GENOA APODMENTS

2000 23RD AVE S | SEATTLE, WA 98144
3032048-EG

EARLY DESIGN GUIDANCE MEETING 2

MEETING DATE:
November 1, 2018 6:30pm

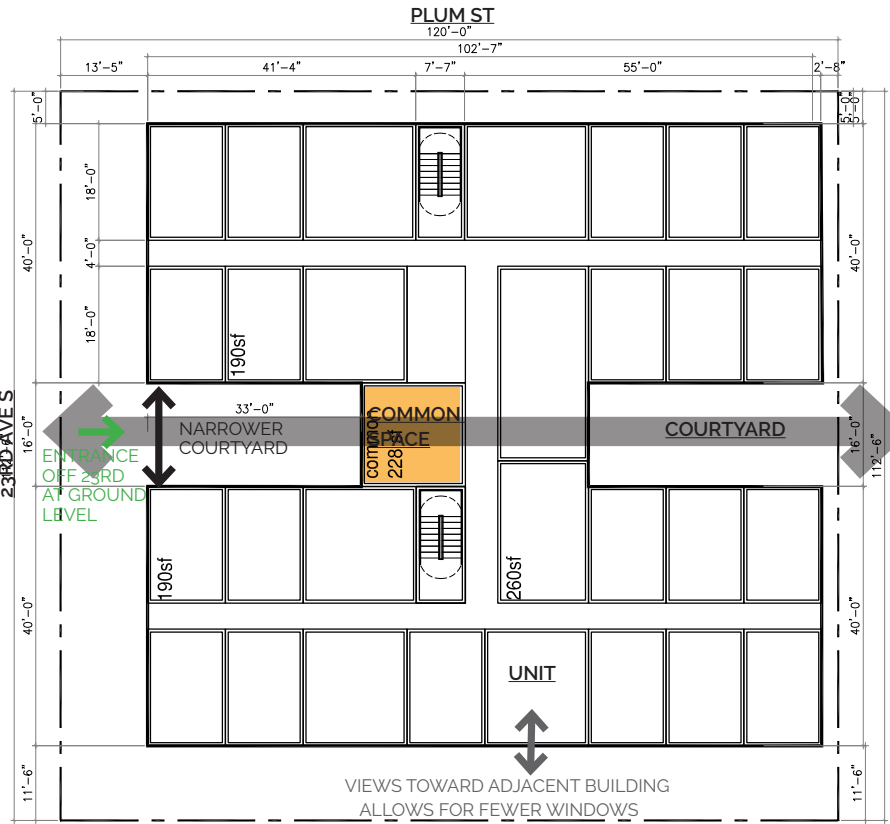
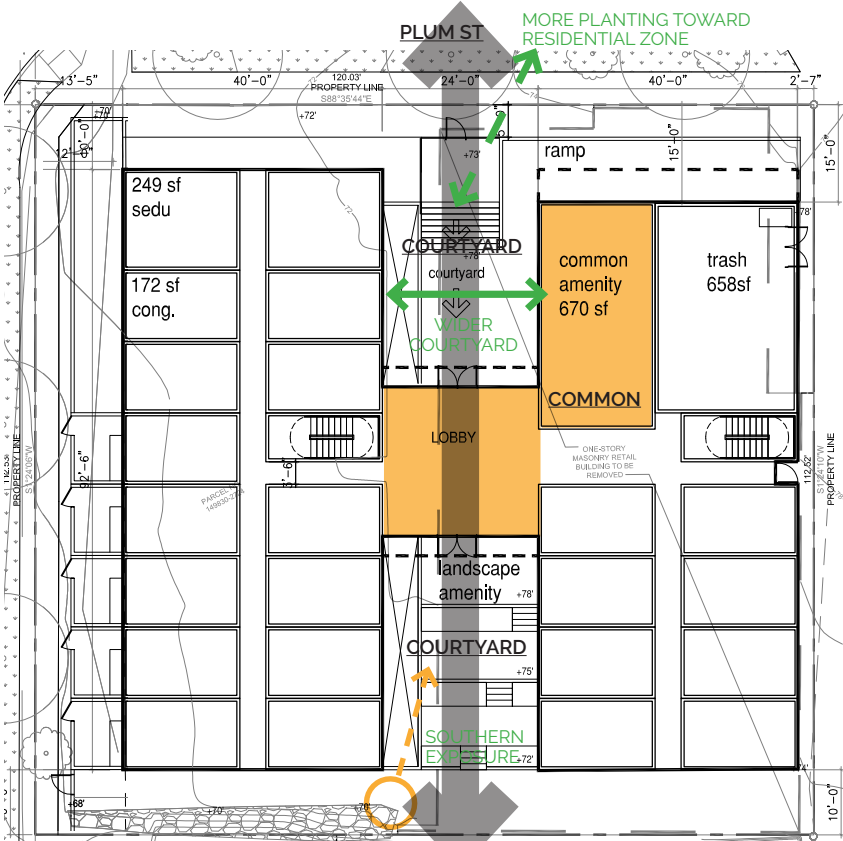
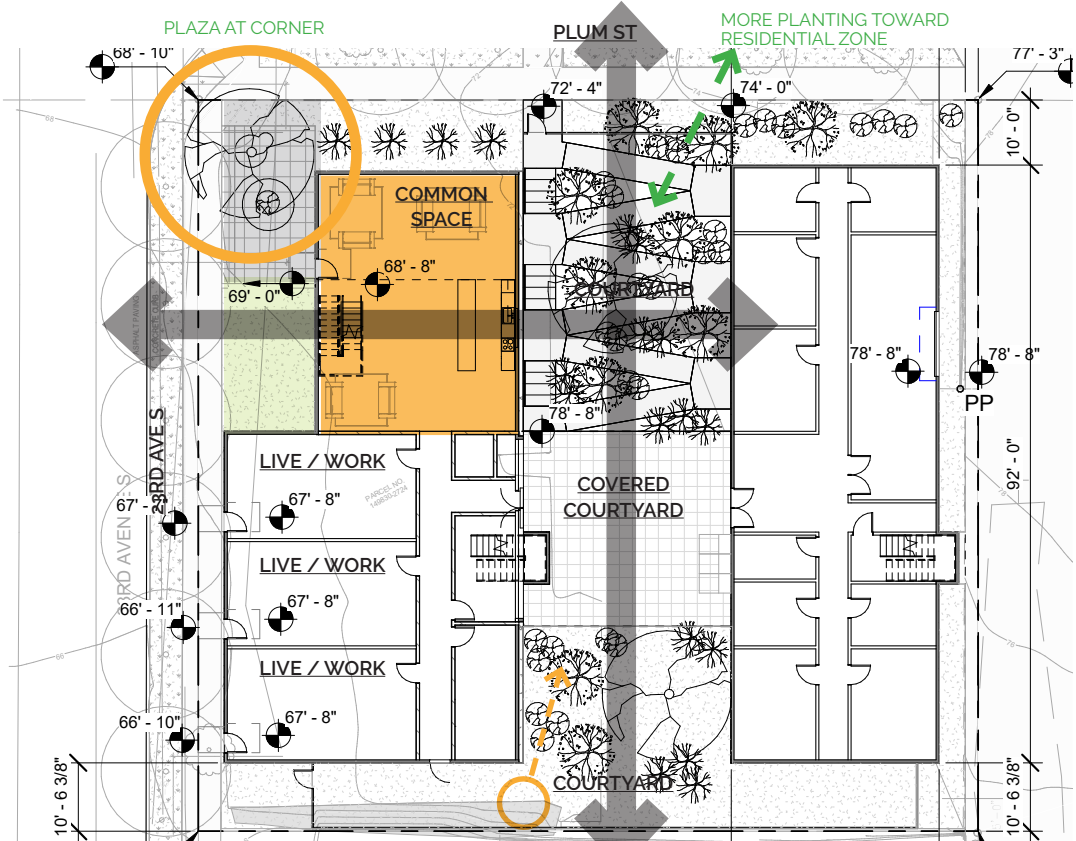
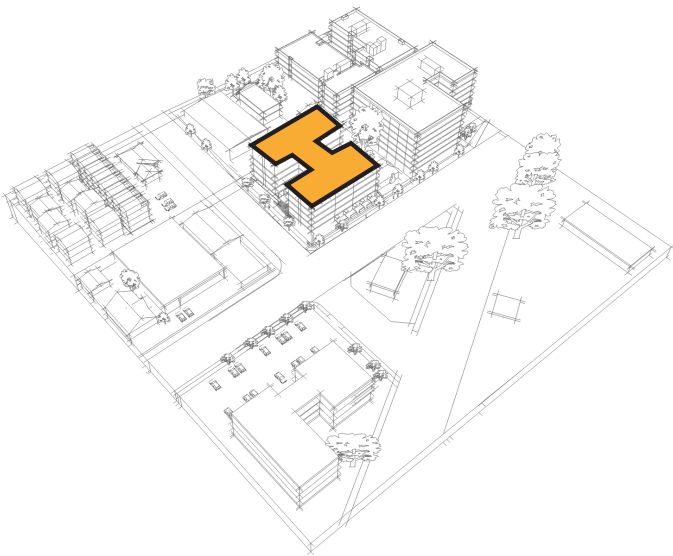
The Board expressed **support** for scheme 1 and 3 and encouraged exploration of a corner courtyard configuration that combines the merits of these two options.

a. The Board discussed the merits of both Option 1 and 3, preferring the courtyard and entry configuration facing 23rd Avenue thereby actively engaging the main street, while also preferring the variety of massing and sensitivity to the neighboring sites shown in Option 3. The Board also preferred the fewer ground level units shown on Option 1. **The Board agreed that a corner courtyard configuration should be explored that combines the strengths of these two options.** (CS1-1a, (PL3-A1 through 4)

The board suggested **additional study** to combine the strengths of each scheme.

23rd Ave S Elevation

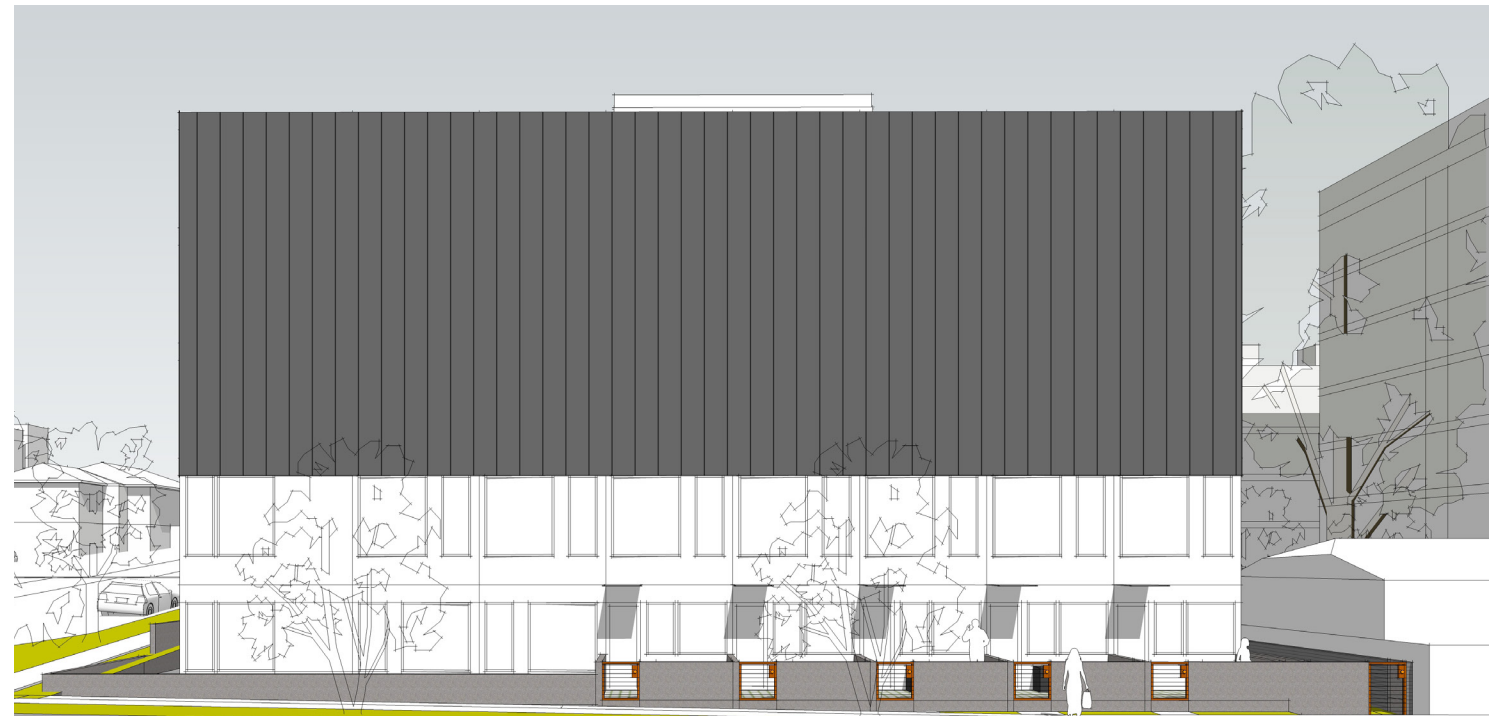
EDG Comment: 2. Orientation of Entry & Connection to Street:

The board looked for activation at the corner of 23rd and Plum and specifically noted the three opportunities to engage the street: the plaza, lobby and common space.

The Board expressed a strong preference for a building entry that engages 23rd Ave and provides a procession of entry sequencing from the public to the private with an open court at the sidewalk edge moving into a more semi private space at the entry point that activated by the common space. The board encouraged minimizing the number of ground level residential units facing 23rd Ave as this is a busier arterial street that creates a challenging condition for ground level residential to contributing towards activating the street, and encouraged units with a stoop character along Plum to engage the quieter, more residential nature of this street.

RESPONSE:

The corner of Plum and 23d is activated by two stories of residential common space and a generous exterior landscape at the corner. The addition of a residential entry off 23rd provides a procession from the sidewalk, through semi-public landscaping, into the building and through the corner common space. Additionally, ground level units along 23rd are replaced with live-work as a continuation of the commercial space to the South.

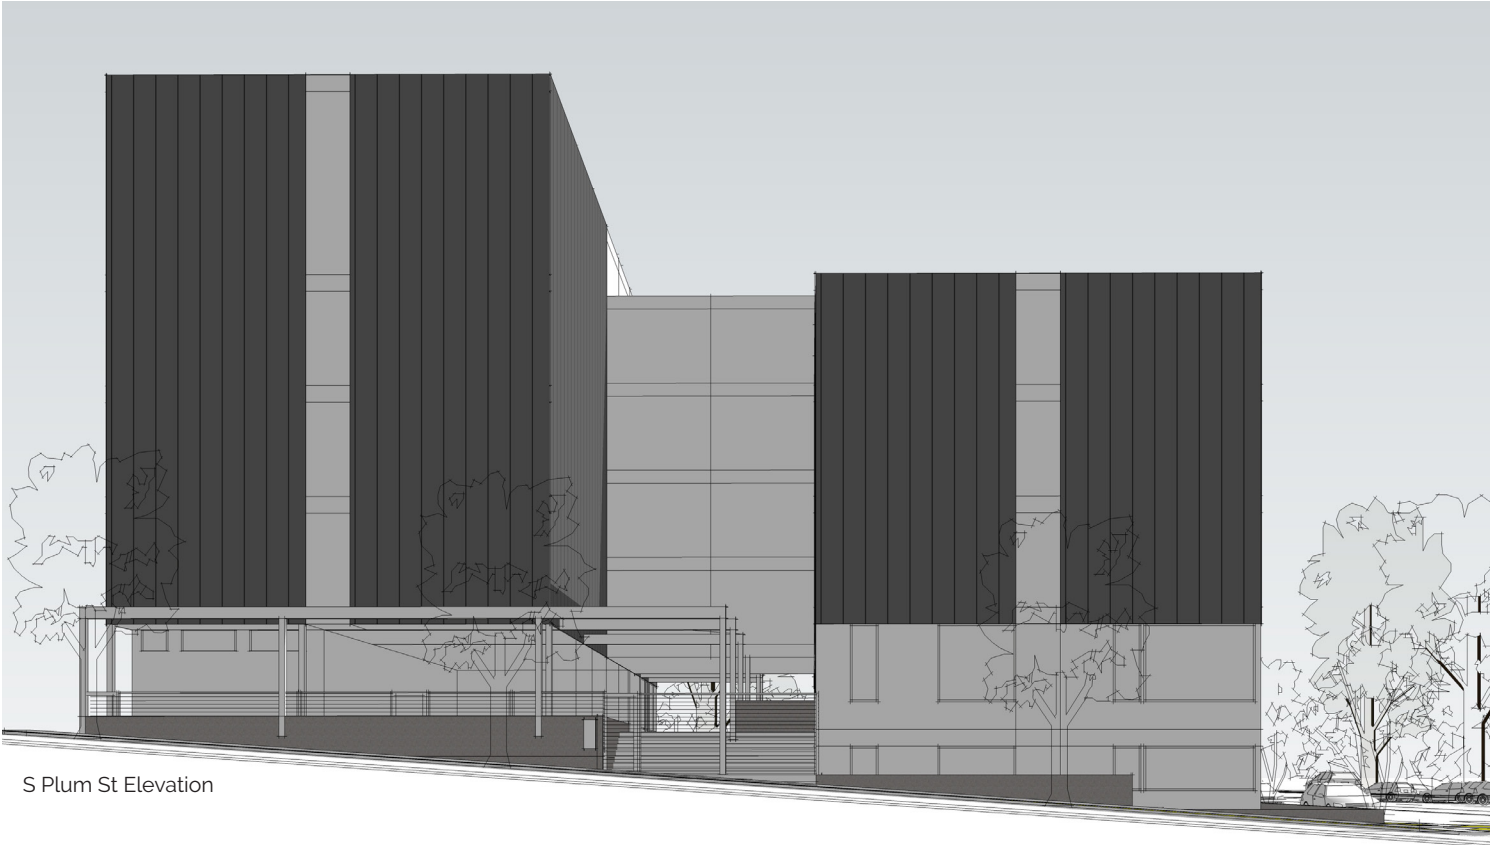
EDG Comment: 2. Orientation of Entry & Connection to Street:

The board looked for activation at the corner of 23rd and Plum and specifically noted the three opportunities to engage the street: the plaza, lobby and common space.

The Board expressed a strong preference for a building entry that engages 23rd Ave and provides a procession of entry sequencing from the public to the private with an open court at the sidewalk edge moving into a more semi private space at the entry point that activated by the common space. The board encouraged minimizing the number of ground level residential units facing 23rd Ave as this is a busier arterial street that creates a challenging condition for ground level residential to contributing towards activating the street, and encouraged units with a stoop character along Plum to engage the quieter, more residential nature of this street.

RESPONSE:

The corner of Plum and 23rd is activated by two stories of residential common space and a generous exterior landscape at the corner. The ground level residential units off of S. Plum street are buffered from the sidewalk and street by landscaping and green space, as suggested from community feedback.

- Landscape and green space will help screen and give privacy to the residential units along S Plum St.
- Vibrant and bold use of pattern to reinforce local cultural references (DC4:1. Building Materials)
- Fencing it is an opportunity for graphic motif and to allow views in and out of site (DC4:1. Screening)
- Cultural and placemaking graphics will enhance sense of place and community.

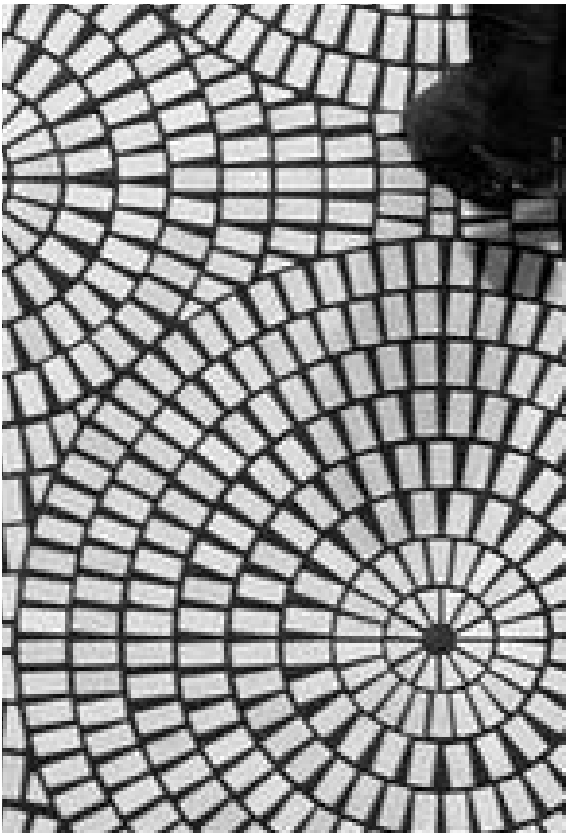
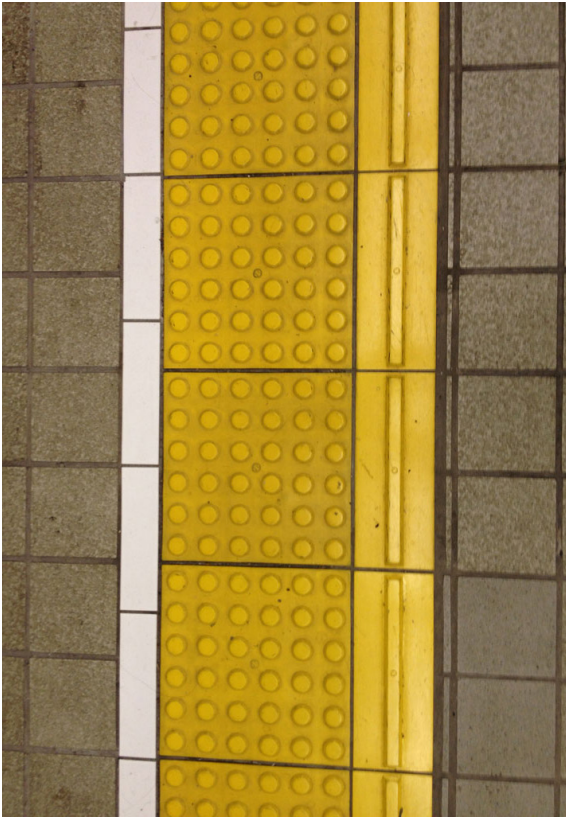
EDG Comment 7. Materials & Building Design:

The board looked forward to a material palett that provides a visual sign to the entry of the Central Area neighborhood and cultural placemaking while enhancing the gateway. The board mentioned specifically the materiality of the Northwest African American Museum as a reference.

RESPONSE:

A visually striking motif will wrap the corner at 23rd and Plum. The Central Area Design Guidelines promotes the use of vibrant and bold materials and texture to reinforce local cultural references and create a distinctive sense of place (CS2-A-1 Sense of Place).

Along 23rd, materiality will be more reflective of the solid, durable materials of the Northwest African American Museum, as the board recommended, with the use of brick on the commercial live work space. Materiality of residential spaces at upper levels will reflect the more materials and character of the neighborhood and use.

WEST / EAST
BUILDING SECTION

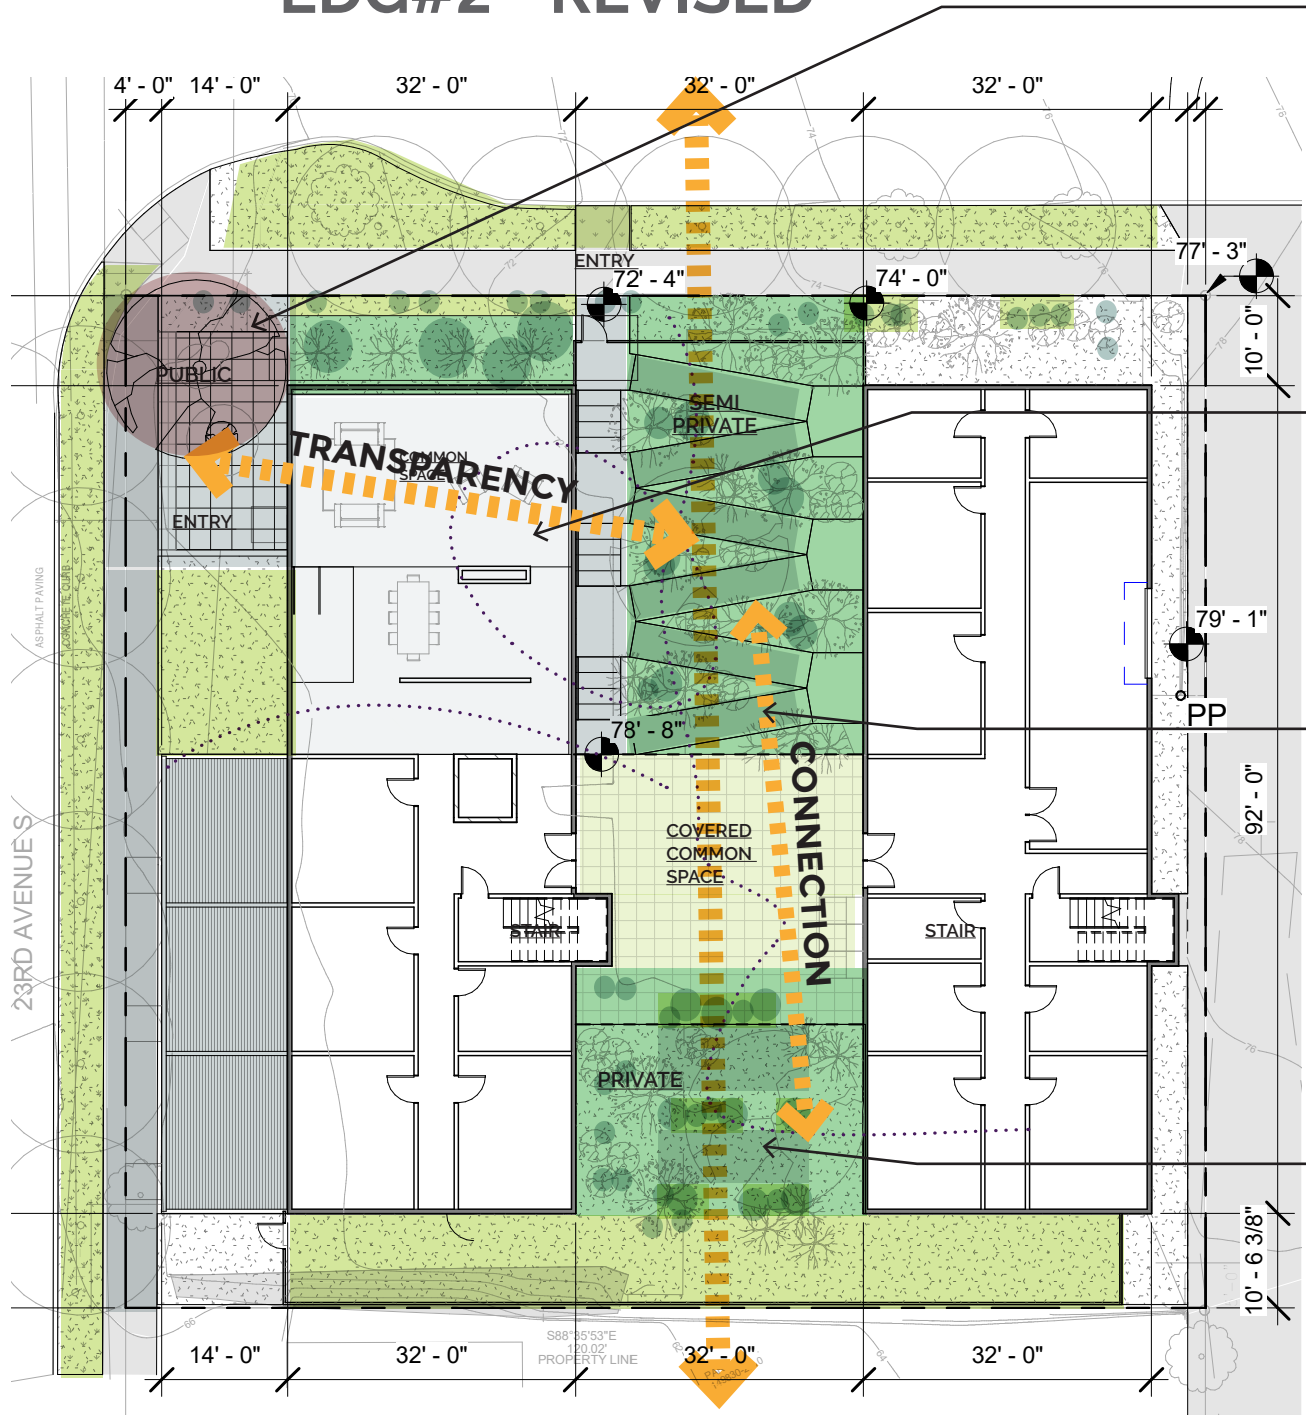
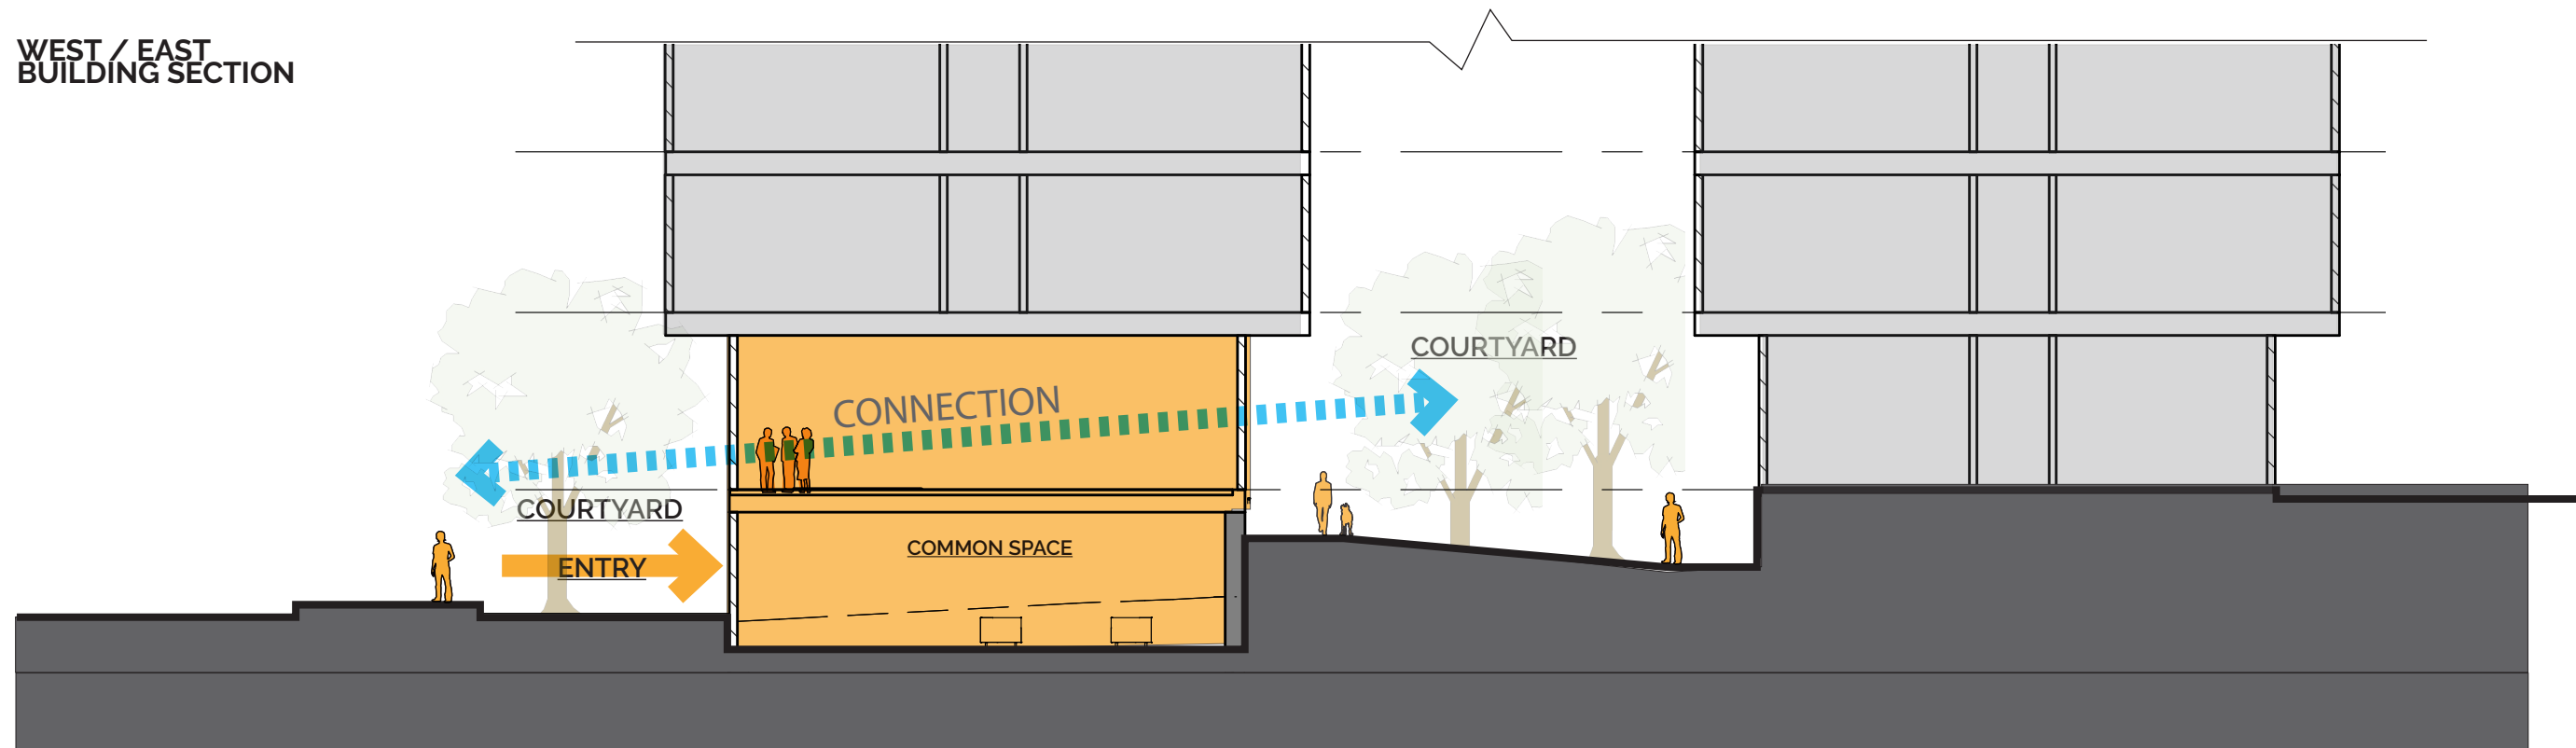
EDG Comment: 4. Open Space Connectivity:

The Board would like to a continuation of the thoughtful manner in which the two courtyards were configured in Option 3 to have a **visual connection and relationship between the open space with the lobby and common space.**

EDG#2 - REVISED

- Create corner plaza and useable open space - (PL1:1b Accessible open space)
- Provide generous common, open space, including shared courtyards and plazas that serve as extensions of the adjacent public realm. (DC3:1c. Common Open Spaces)
- Incorporate transparent and open indoor community meeting spaces at the ground level. (PL1:1c Accessible open space)
- Provide safe and well connected open space. (PL1:1a Accessible open space)
- Prioritize common, accessible, ground level open space at the building street fronts and/or with courtyards that are not restricted or hidden from street views. (PL2:2d Connection back to the community)
- Provide multi-generational community gathering spaces for young and old to recreate and converse together. (PL2:3d Livability for Families and Elderly)

Progression and **sequence of space** as you move through the landscape.
